**FILE:** 621350-, Bartow County  
STP00-0012-01(071)  
SR 20 Widening and Relocation from  
US 411/SR 61 to I-75

**SUBJECT:** Request for VE Reversal

**Reference: SR 20 Widening and Relocation from SR 61/US 411 to I-75  
Project No. STP00-0012-01(071); PI No. 621350  
Bartow County**

**DESCRIPTION:** RECYCLE EXISTING PAVEMENT ON SR 20 **SHEET NO.:**

TS-2  
 TYPICAL ROADWAY SECTION  
 SR 20  
 SUPERELEVATED SECTION  
 STA 20-00 TO STA 24-60  
 STA 31-18 TO STA 63-47  
 STA 76-00 TO STA 104-19  
 STA 115-75 TO STA 133-53

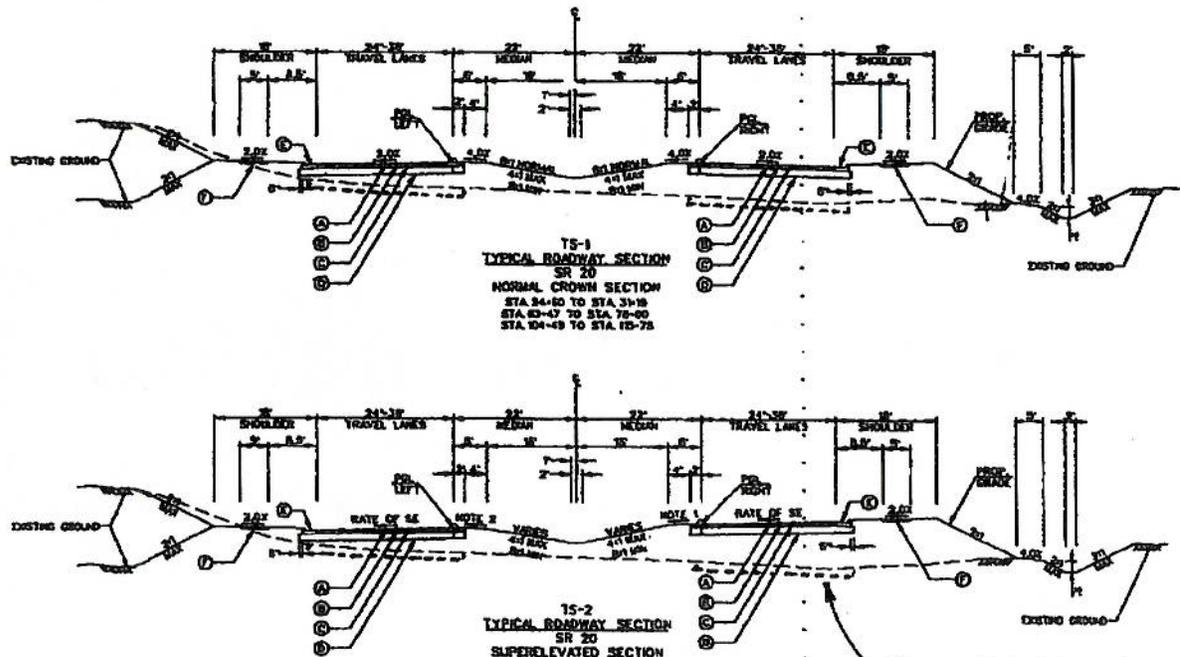
An alternate use for the existing roadway is not addressed in the plans or the estimate. The proposed profile eliminates the possibility of reusing the existing pavement as part of the new roadway. The existing pavement and base from STA 59+00 to STA 133+83 could therefore be recycled which should result in significant savings.

An alternate use for the existing roadway is not addressed in the plans or the estimate. The proposed new profile eliminates the possibility of reusing the existing pavement as part of the new roadway. The existing pavement and base from STA 59+00 to STA 133+83 could therefore be recycled which should result in significant savings.

Since the VE Study was held, changes to the design profile have been incorporated to accommodate extensions of existing culverts for environmental constraints, which eliminates the ability to overlay the existing pavement from Sta. 59+00 to Sta. 71+00. Also, based on information obtained on the existing pavement structure, the existing pavement and base do not appear to provide sufficient structural capacity to accommodate an overlay of the existing pavement based on the existing pavement structure, revised traffic volumes and truck traffic projections.

Implementation of Alternative RD-20 has been incorporated into the design from Sta. 126+00 to Sta. 133+50. The cost savings realized in this location based on the current pavement design and construction costs is \$156,606. The estimate is based on the cost difference between a full depth pavement section and a milling and overlay section. Both pavement designs are approved pavement design sections for this project.
